GREAT GROVEHURST FARM  
SITTINGBOURNE  
KENT

SUPPLEMENTARY STATEMENT  
(29.11.21)

BRICKEARTH EXTRACTION METHOD  
STATEMENT AS REQUESTED BY  
PLANNING PERMISSION 18/502372  
(JULY 2021)

Drawing No.  
**D118/14** Rev E

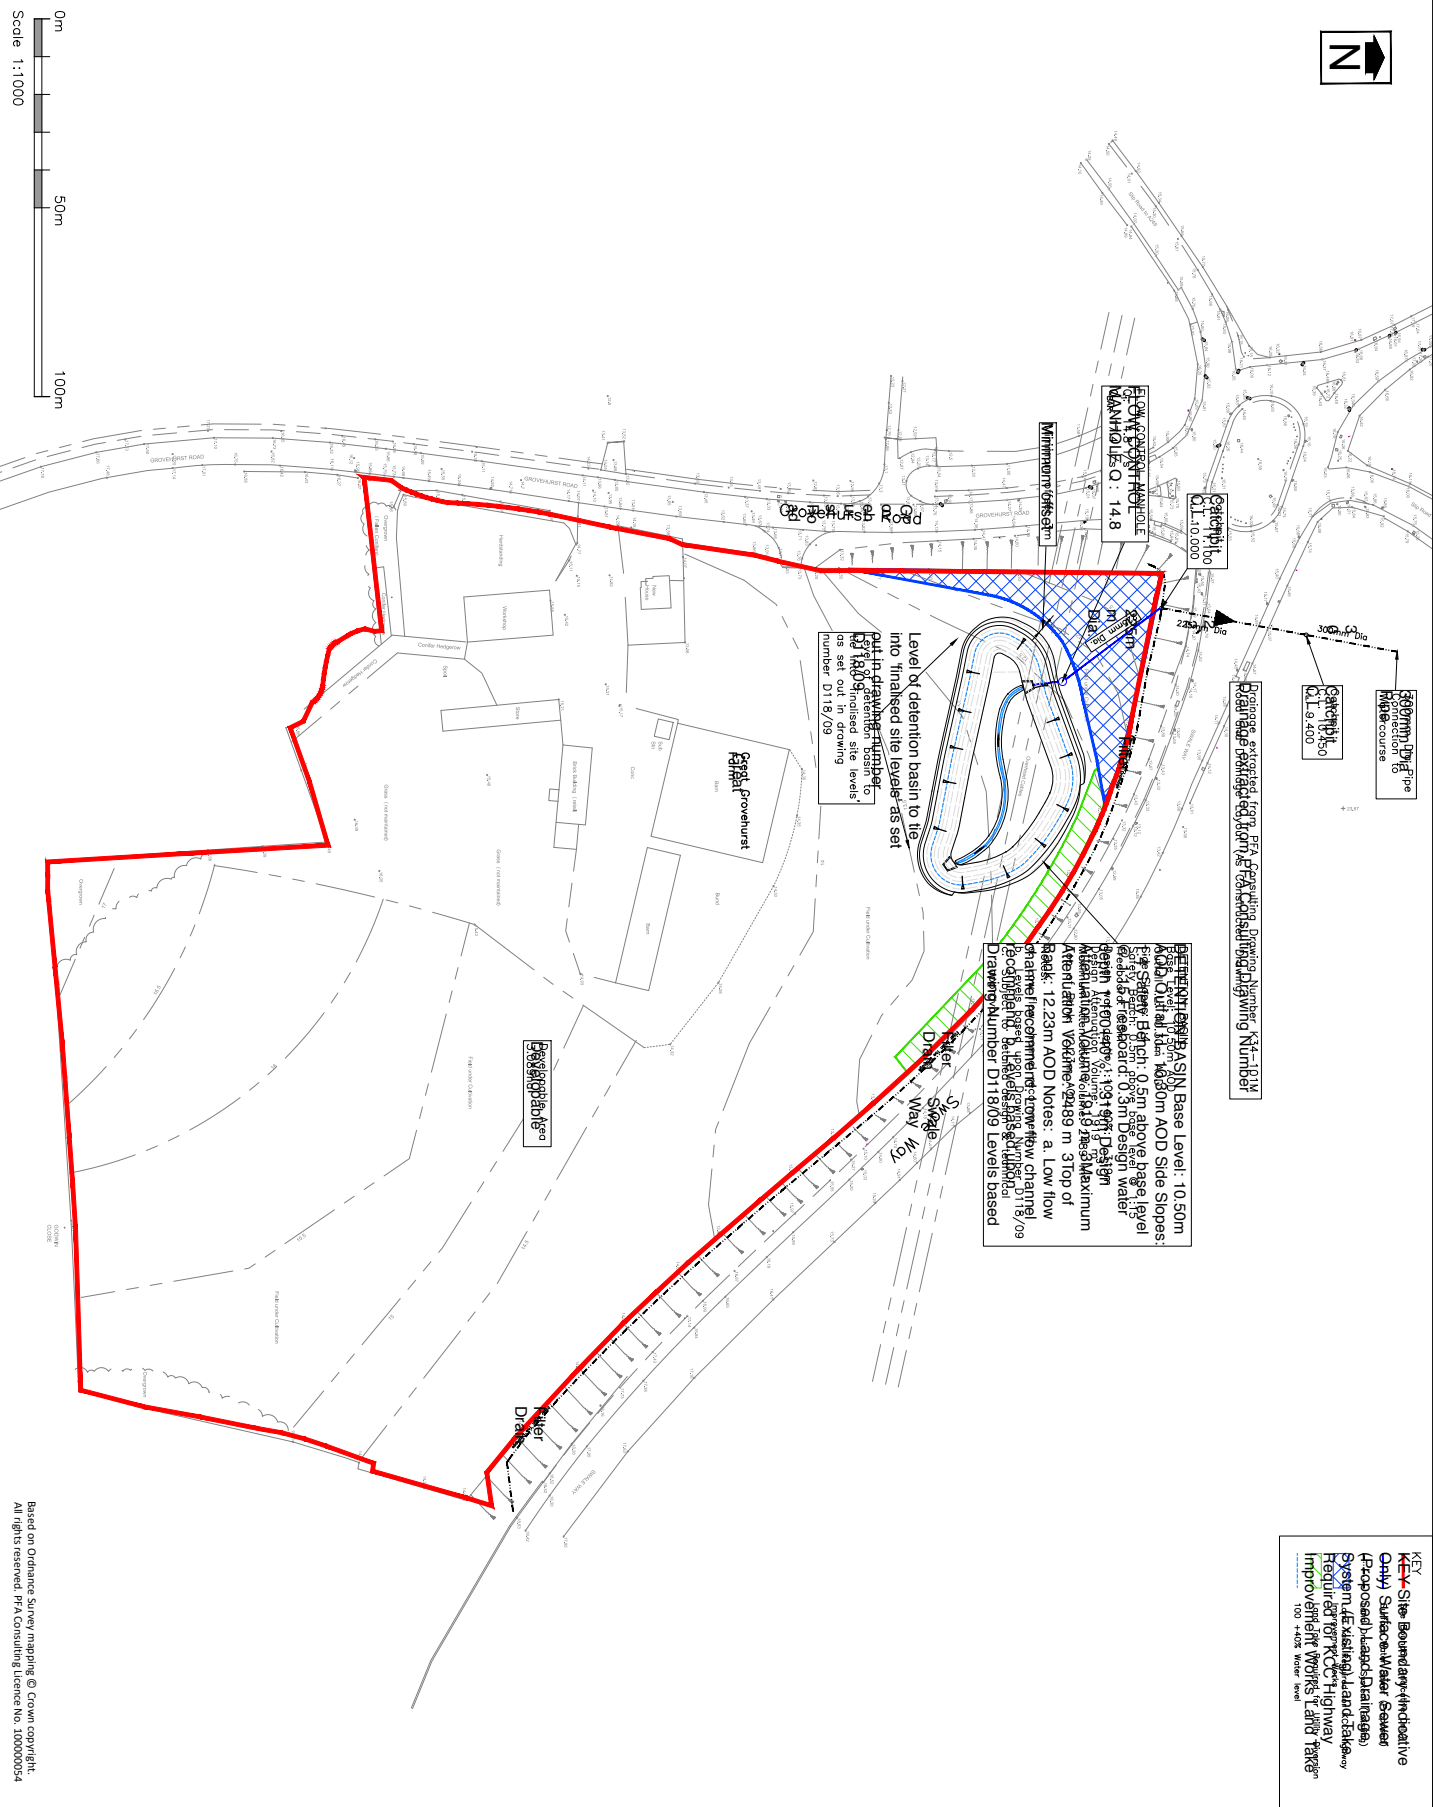
- 1.7 In the unlikely event that brickearth is removed by Wienerberger from the land required for highway improvements (cross hatched blue on the plan in Appendix 1) then the land will be reinstated to existing ground level before transfer to KCC. The material for reinstatement and the method of compaction will be agreed with KCC before the brickearth is extracted.

- 1.8 Drawing D118/D14RevE contained in Appendix 1 to this Supplementary Statement shows details of the proposed detention basin to be located in the north west corner of the site incorporating levels that have been agreed with KCC. This drawing is now formally incorporated in the Brickearth Extraction Method Statement.

Level of detention basin to the  
 into finished site level as set  
 out in drainage plan to be  
 set out in drawing  
 number D118/09
